CITY OF MOBILE
TIGER 2016 Project Phase Four- Dr. Martin Luther King Jr. Ave from NW of Butchers
Lane to Beauregard St
Project No. 2023-2045-01

ADDENDUM #2

This addendum includes the following: (1) revised contract language, (2) revised PROPOSAL form (Attachment "A"), (3) responses to remaining questions and (4) updated plan sheets (Attachment "C"). This addendum consists of a total of 93 pages, including the cover page.

SUMMARY OF PLAN SHEET CHANGES

REFERENCE PROJECT NO	FISCAL YEAR	SHEET NO
2023-2045-01 TIGER-FAUP-4917(250)	2025	414

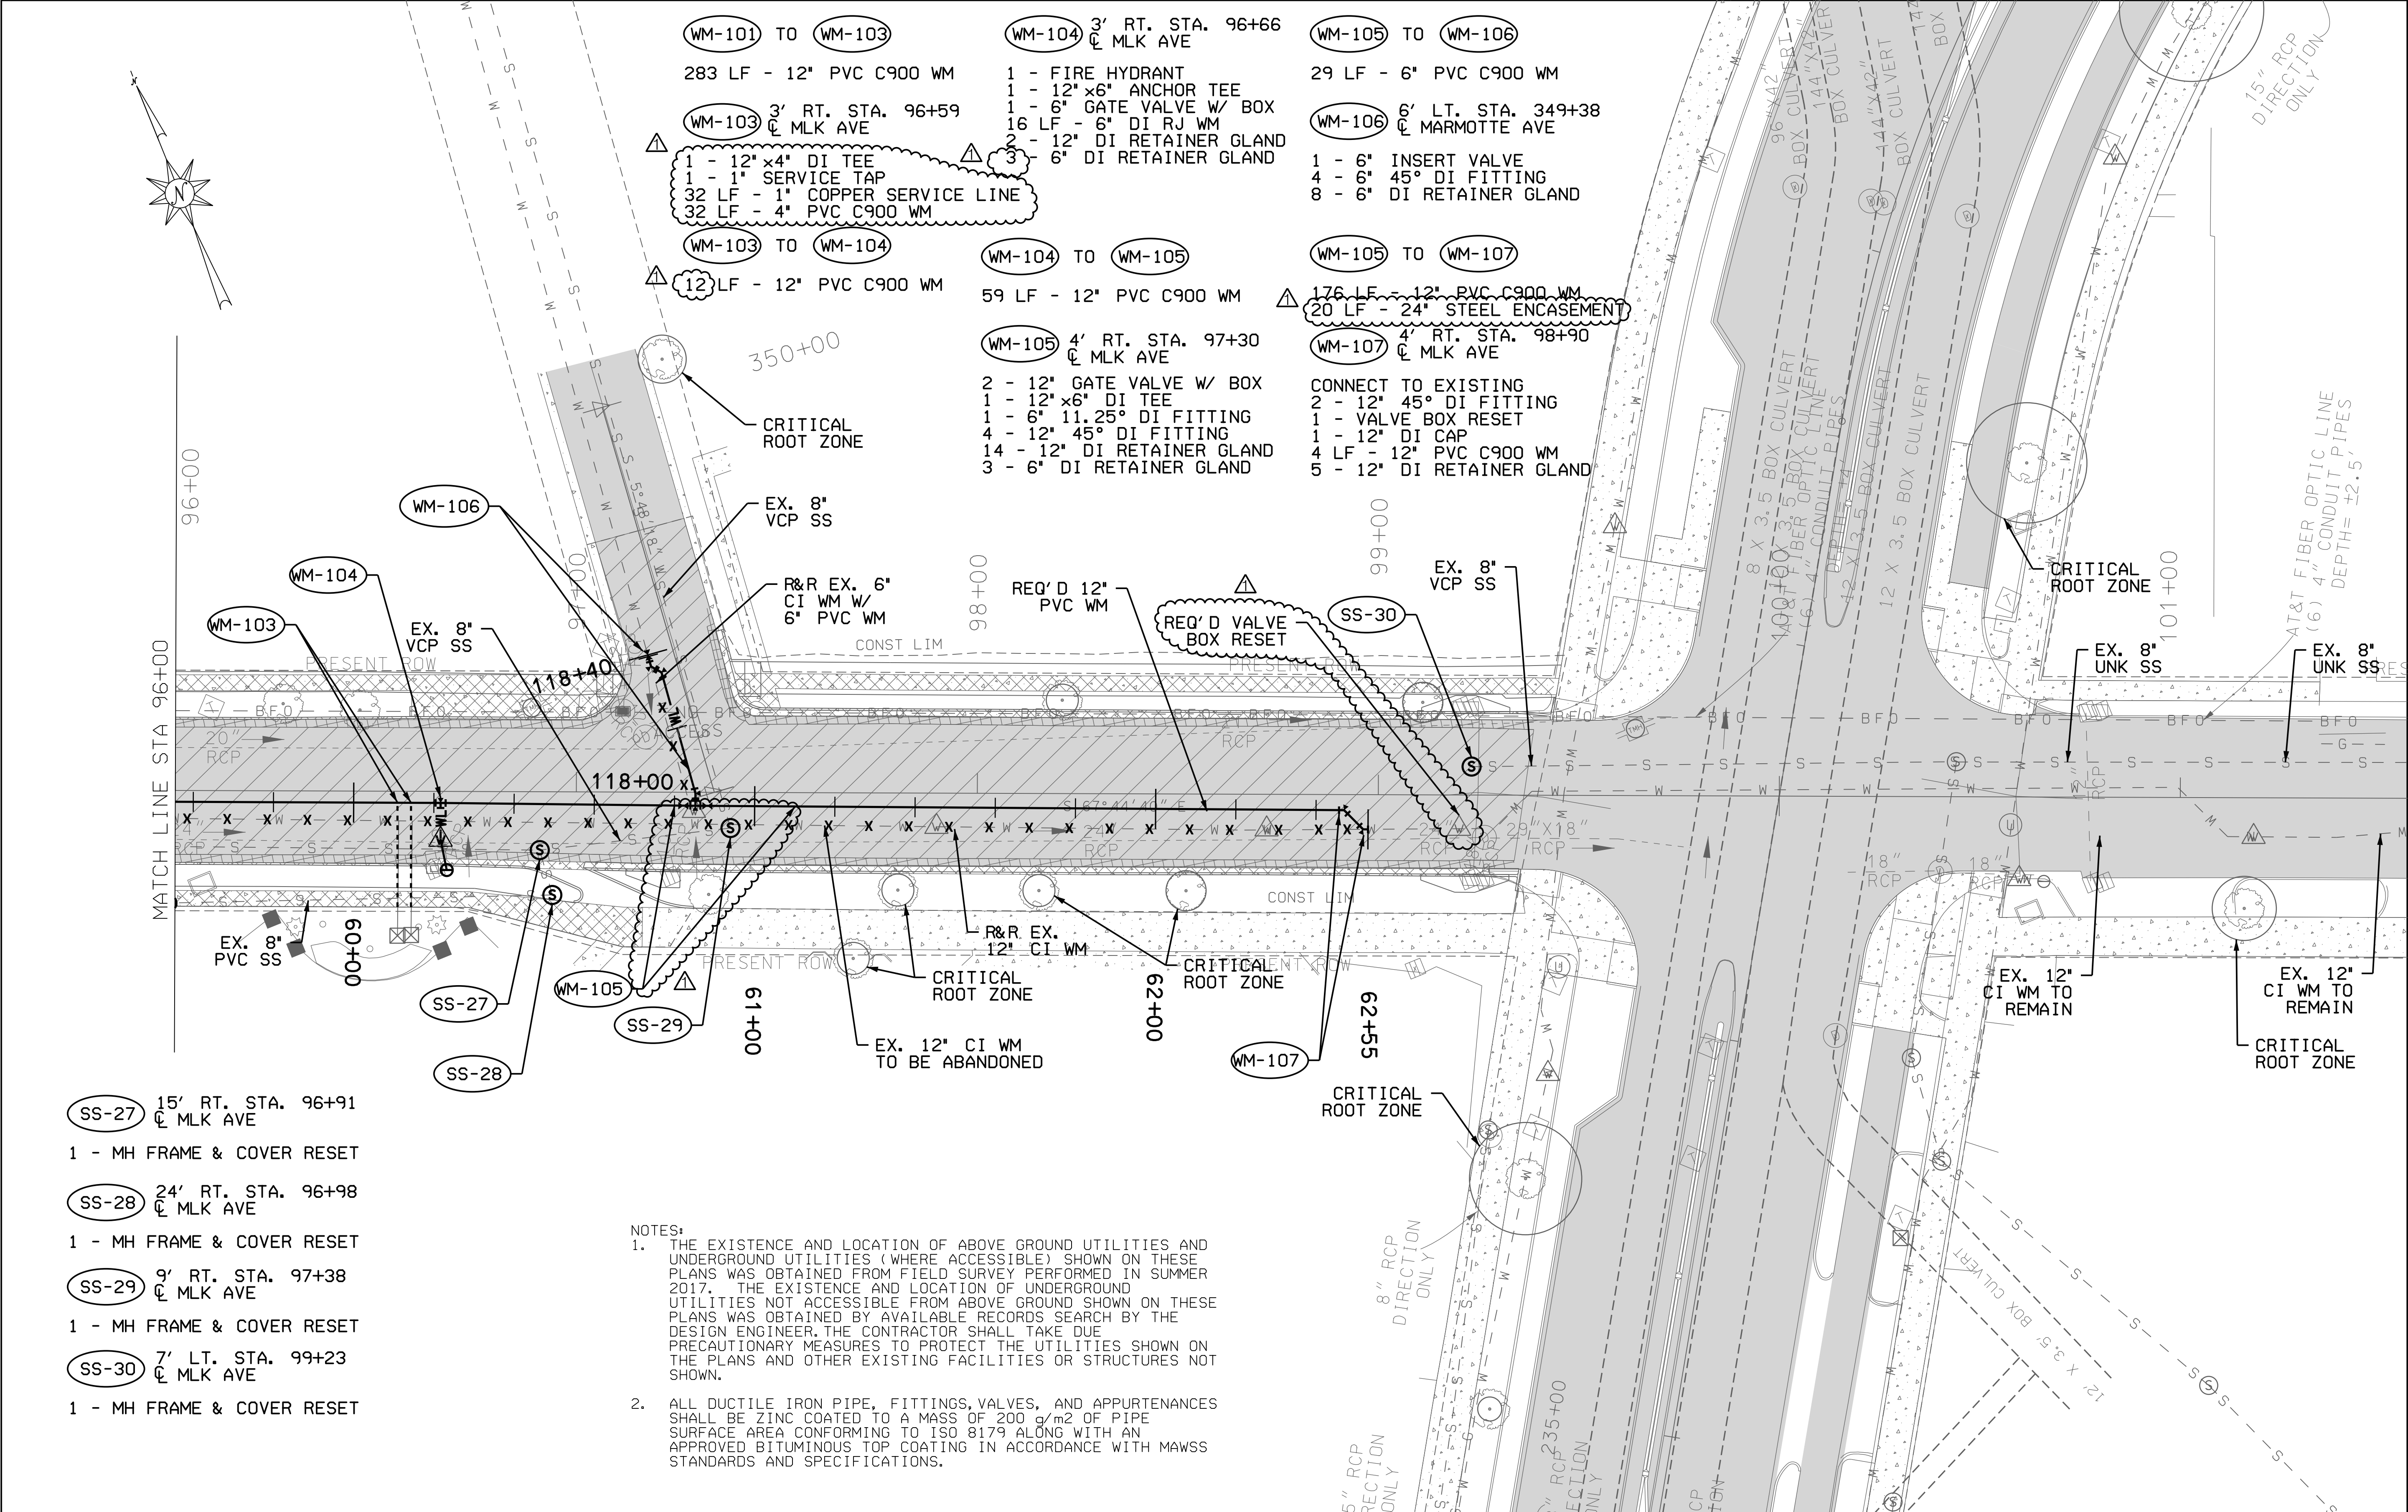
- 1 – Fire Hydrant
 - 1 – 6"X6" DI Anchor Tee
 - 1 – 6" Gate Valve W/ Box
 - 10 LF – 6" DI RJ WM
 - 5 – 6" DI Retainer Glands
- **SHEET 414**
 - Callout WM-103 – Modified 12"x3" tee to 12"x4" tee and revised copper service line length

- Callout WM-103 to WM-104 – Revised pipe length quantity
 - Callout WM-104 – Revised 6" retainer gland quantity
 - Callout WM-105 to WM-107 – Added 20 LF of 24" steel encasement

- Callout WM-105 – Modified leader arrows
 - Added additional valve box reset near Callout SS-30
- **SHEET 414A**
 - Callout WM-105 – Added callout for 24" steel encasement

BRIDGE-MOUNTED CONDUIT DETAIL

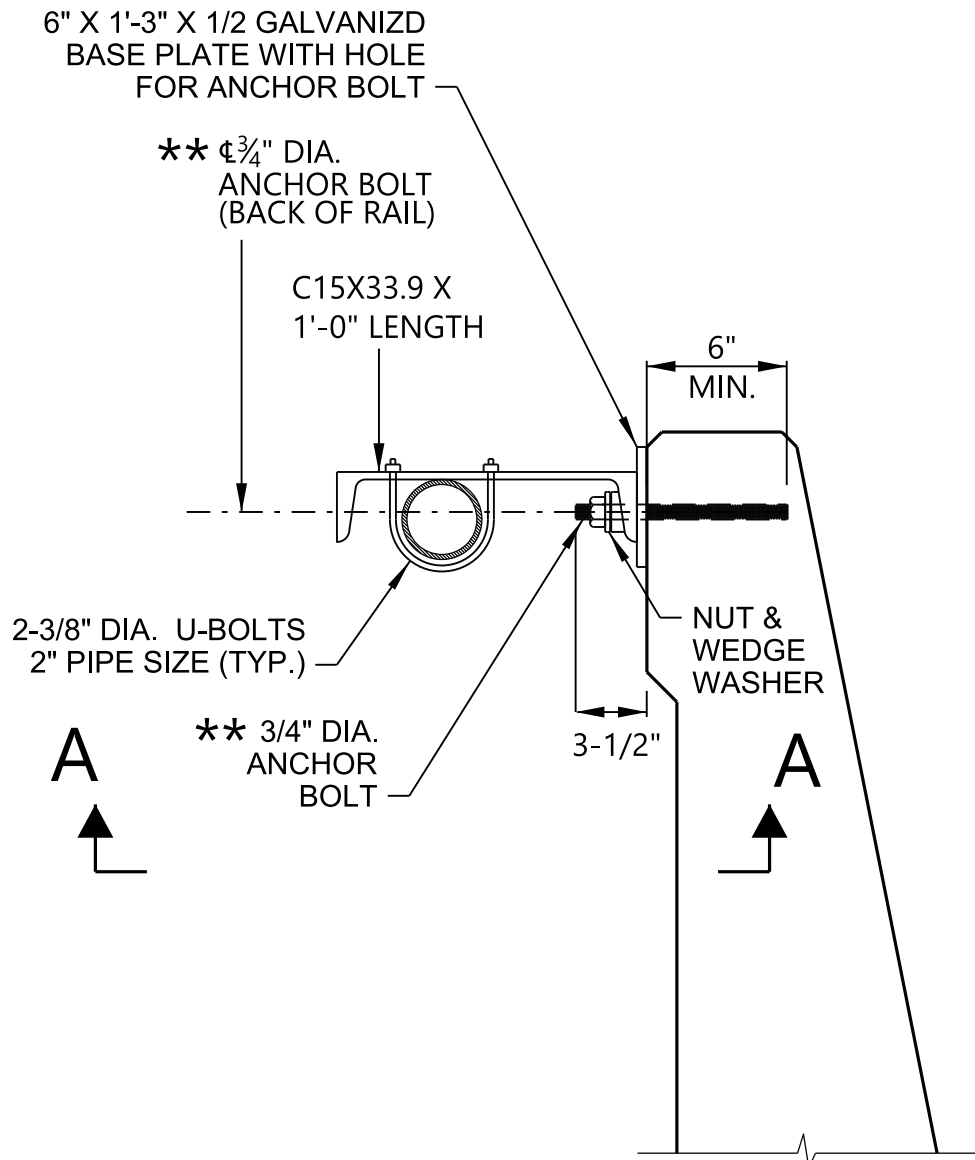
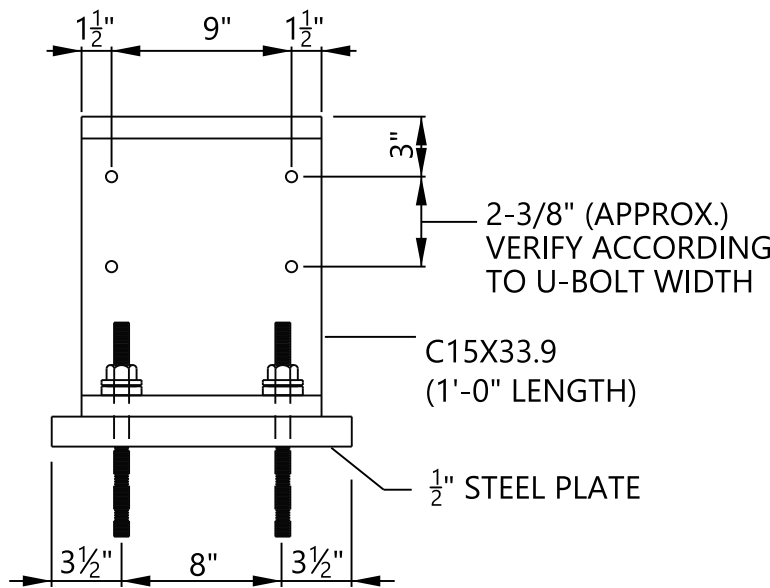
- **SHEET 420-433**
 - Notes consolidated and clarified to be for all Bid Alternate – Conduit for Future Use Sheets
- **SHEET 435**
 - Note 5 added: Refer to ALDOT Special Drawing RLD-001, Index No 75026 for connection from bridge mounted conduit to ground mounted junction box.
